AEM Wideband Update

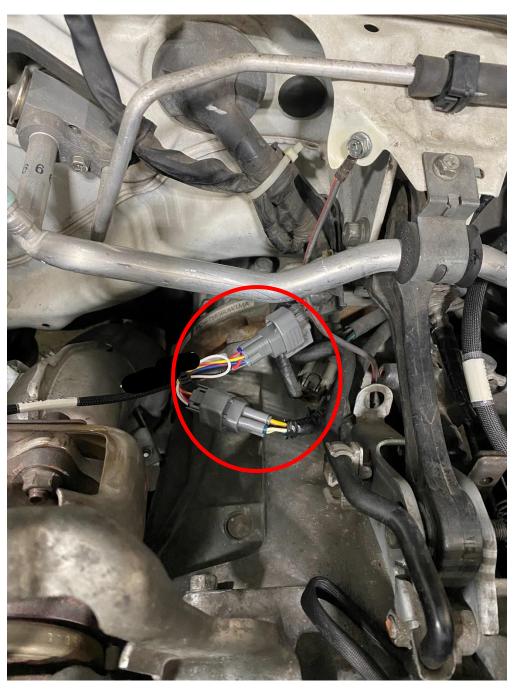
Due to the Cobb Accessport Green Speed update, we modified the harness to jump between the bulkhead and the Rear 02 connectors so the wideband can be utilized without logging and disabling the Rear 02 sensor. If you can log via an alternative tuning platform (ECUtek, Opensource, Standalone, etc.), you can adjust the harness to utilize the logging feature.

If you want to utilize the logging feature, this will disable the rear 02 sensor and trigger a check engine light. Move the switch over to the "LOG" side of the switch and adjust the ECU parameters to accept this as an input.
